# Special Council Meeting

4 March 2021

# 6. Lot 544 (No. 105) Broadway, Nedlands – Mixed Use Development comprising 22 Multiple Dwellings and Office – Responsible Authority Report

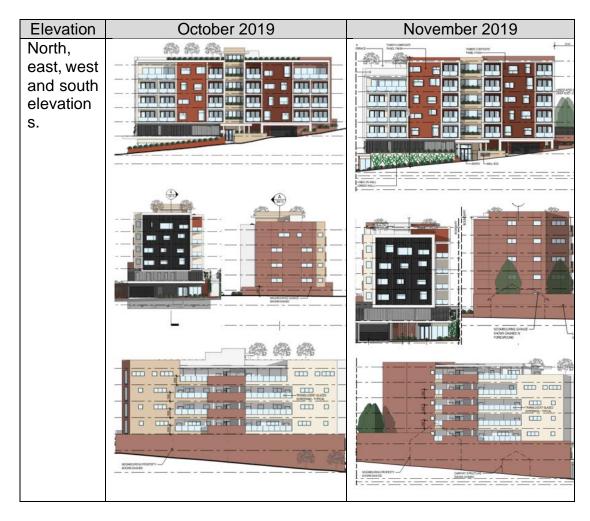
It is expected that built form controls will seek to ameliorate the impacts of the transitions in density coding, such as on this site which is coded R-AC3 and interfaces with R60 to the west and equates to a default interface of 6 storey down to 3 storey height. It is noted that the local planning framework is currently unresolved, and that minimal weight should be afforded to a Council-adopted local planning policy which either seeks to vary built form provisions contrary to the Local Planning Scheme 3 and/or requires Western Australian Planning Commission (WAPC) approval.

Reference can be made to the desired streetscape character outlined and illustrated in Appendix 2 of the Residential Design Codes Volume 2 – Apartments (R-Codes Vol. 2). Being Mixed Use R-AC3, adjacent to Residential R60, the streetscape character is designated as a 'mid-rise urban centre', before transitioning to a 'medium-rise residential setting' at the rear. Proposed buildings are to reflect the prevailing or planned pattern of side and street setbacks and take advantage of the location, aspect and orientation of the site. For the site, pedestrianised street frontages are encouraged to achieve pedestrian scale at the street frontage.
